Commonwealth Edison Company
Quad Cities Generating Station
22710 206th Avenue North
Cordova, IL 61242-9740
Tel 309-654-2241

Quad Cities Nuclear Power Station, Units 1 and 2
Facility Operating License Nos. DPR-29 and DPR-30
NRC Docket Nos. 50-254 and 50-265

Subject: Changes to Emergency Plan Implementation Procedures

Attachment A, Summary of Changes
Page 1 of 2

FIGURE 6.3-1B
PROTECTIVE ACTION RECOMMENDATIONS

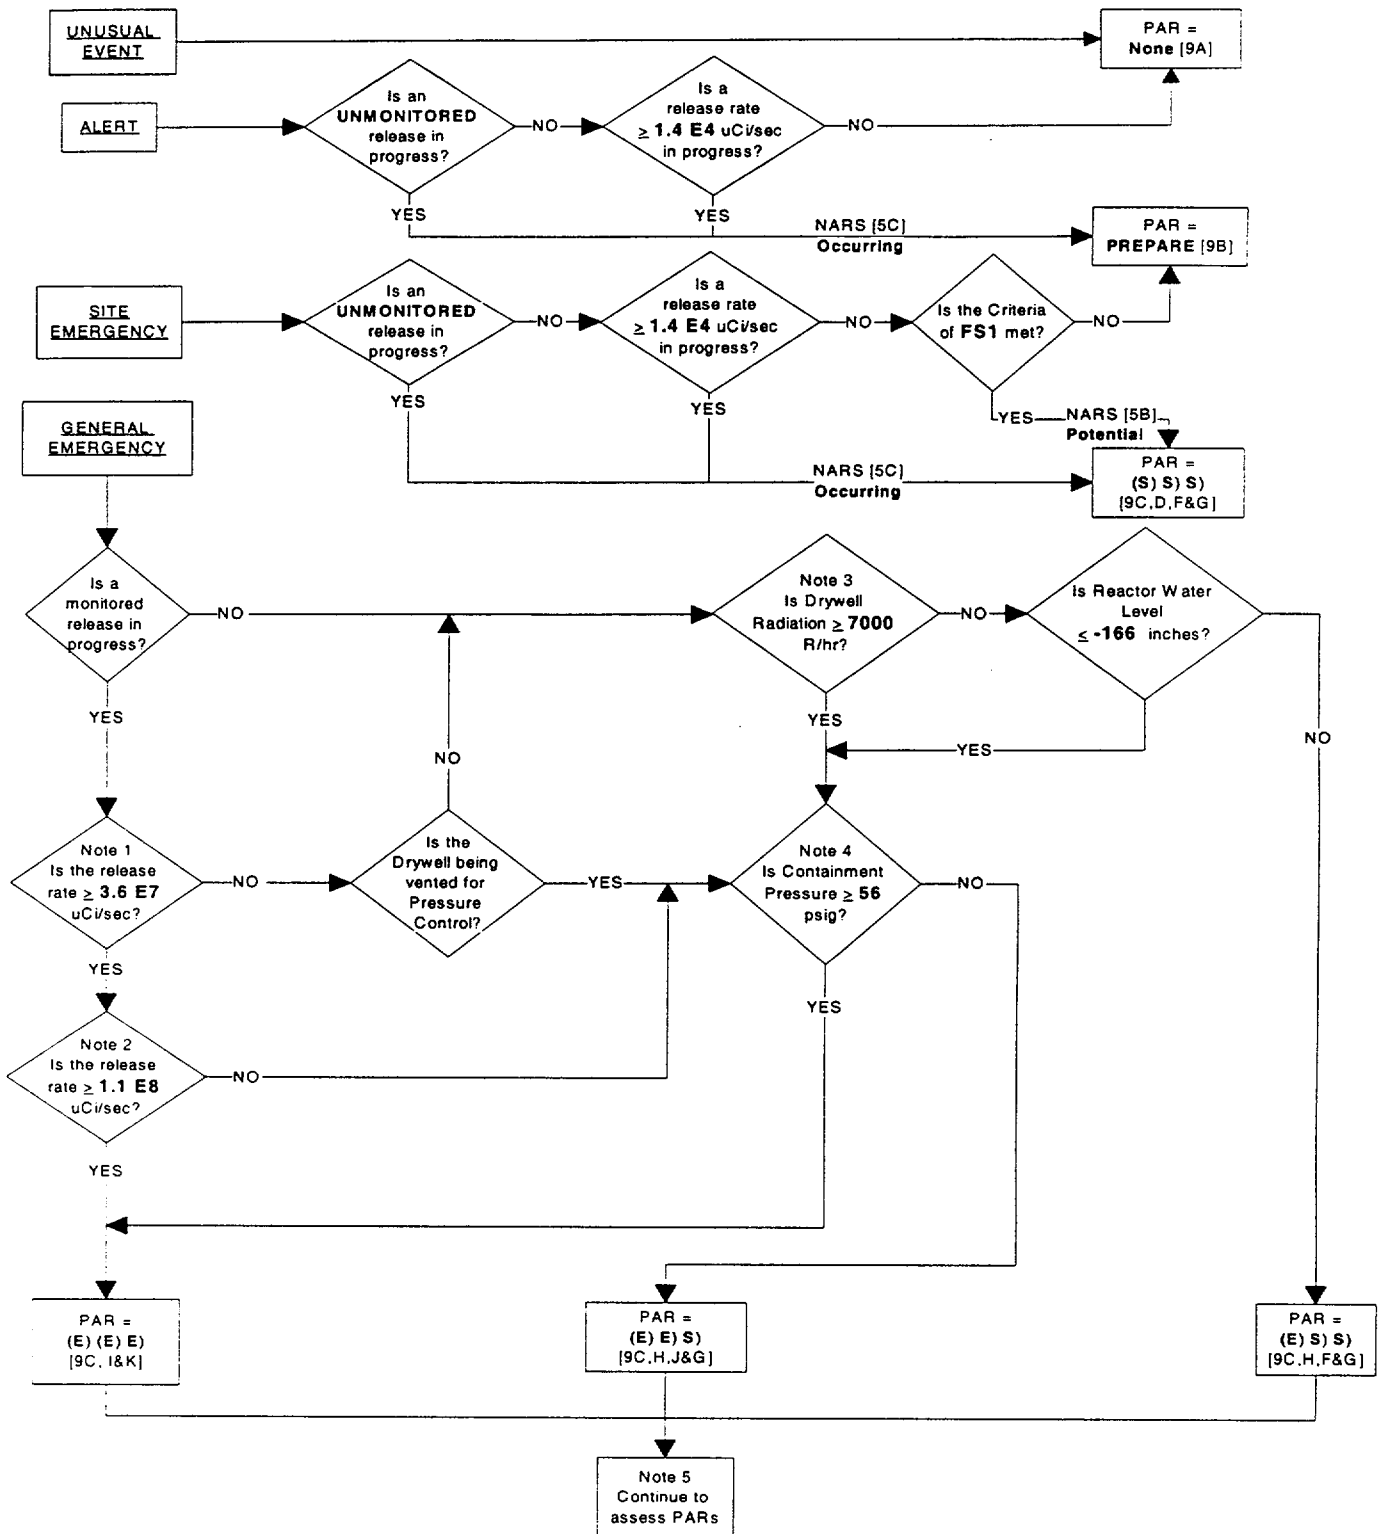
QEP 0150-T09 "Protective Action Recommendations," Revision 10

Decision points for release status inserted on PAR flowchart.

PREDETERMINED PROTECTIVE ACTION RECOMMENDATIONS (PARs) FOR CONTROL ROOM

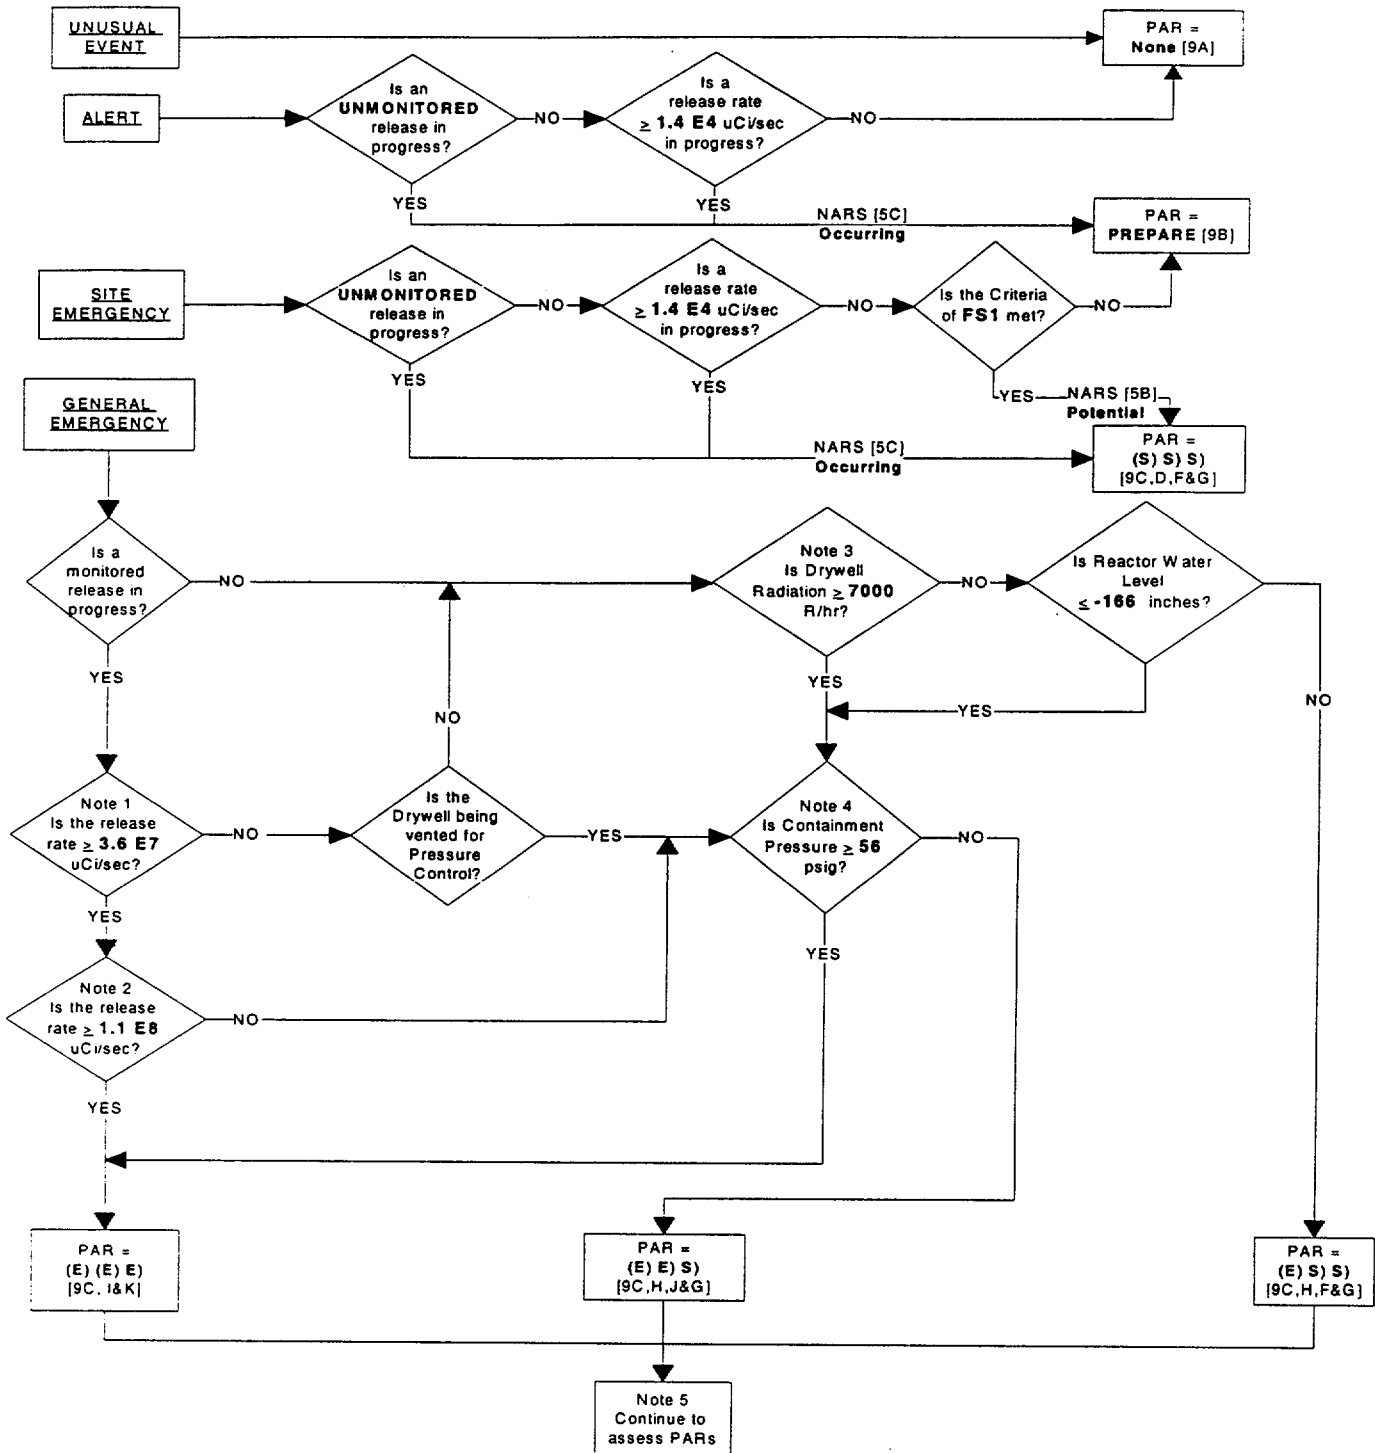
QEP 0100-T02 "Predetermined Protective Action Recommendations (PAR's) For Control Room," Revision 13

Integrated release criteria into PAR flow chart

SITE EVACUATION MAP
(To Byron Station - Alternate Relocation Center)

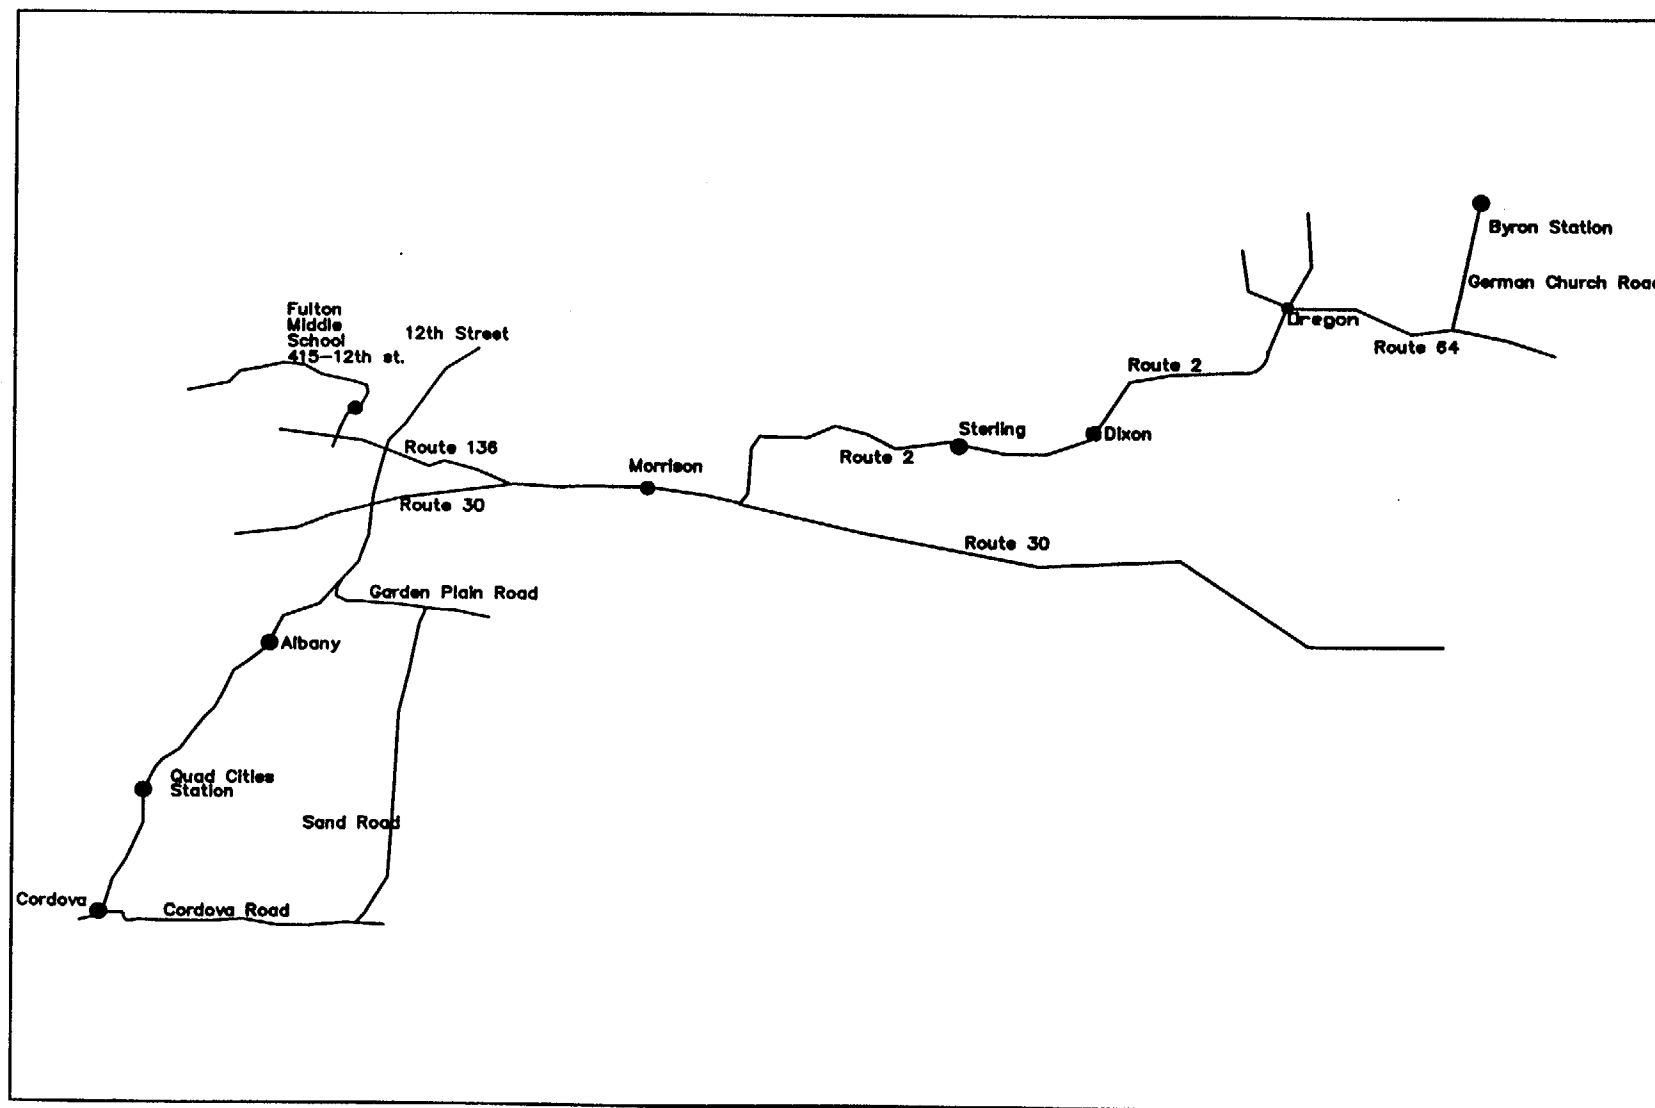
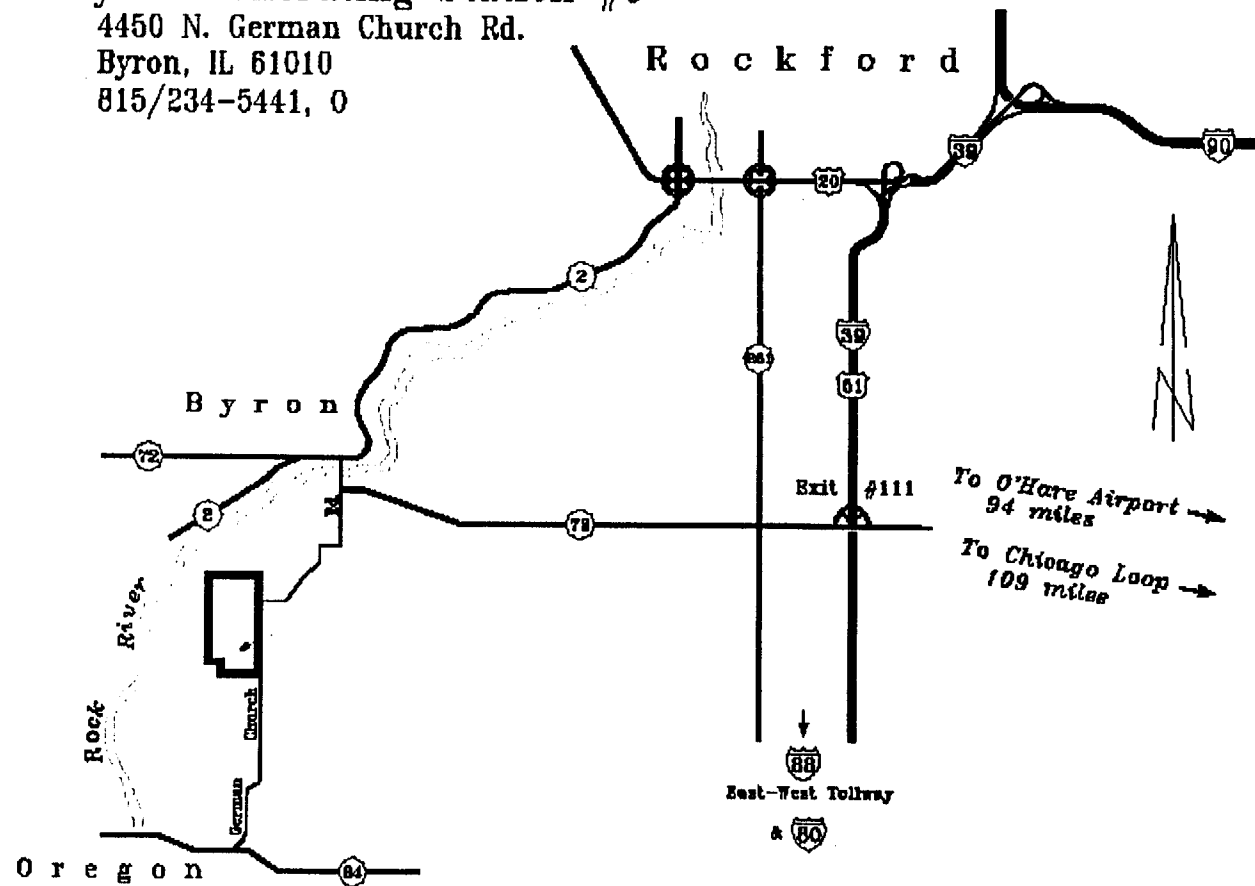
QEP 0400-T02 "Site Evacuation Map," Revision 7

Inserted a map for Byron station
